"LITTLE EVY" ex "Uaian" (No. 80087 in Register Book).
Conversion to Motor Vessel.

IT IS SUBMITTED the Rotterdam Surveyors be informed that the diagrammatic plan of lubricating oil and compressed air piping arrangement merits approval provided the arrangement be as shown and amended on the plan and the remaining requirements of Sections 5 and 6 of the Rules for Heavy Oil Engines (1934-5) be complied with so far as they are applicable.

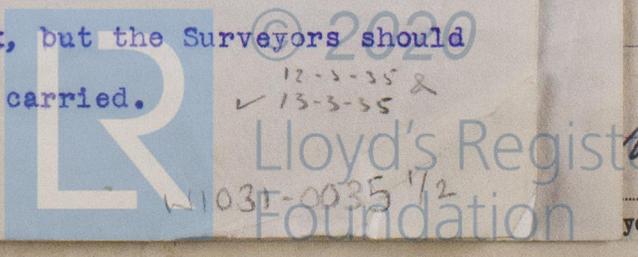
With reference to the plan of bilge and ballast pumping arrangement, it appears from the First Entry Report that three branch bilge suction, one donkey pump direct suction and one bilge injection were originally fitted in the machinery space and it is considered that wing suction should be retained as now indicated on the plan. Further, these branch suction should be led from mud boxes fitted with straight tail pipes, as required by Section 34, Clause 6(g). ✓ 13-3-35

It is noted that the centrifugal bilge pump is driven by the main engine and the Surveyors should be requested to forward full details of the drive of this pump and the auxiliary air compressor. ✓ Section app. 15-3-35

It is concluded that the air compressor can be driven by the auxiliary engine, and that this engine can be started by hand, but this should be confirmed. ✓ 12-3-35

The Surveyors should also be requested to state the size of the ballast pump and whether the donkey boiler will always be under steam when the vessel is at sea. ✓ 50 tons ND 12-3-35

In this connection plans of the oil fuel piping arrangement should be submitted for consideration. ✓ App 12-3-35

It is further concluded that oil fuel will not be carried in No. 4 double bottom tank, but the Surveyors should state in which tanks oil fuel will be carried. ✓ 12-3-35 & ✓ 13-3-35
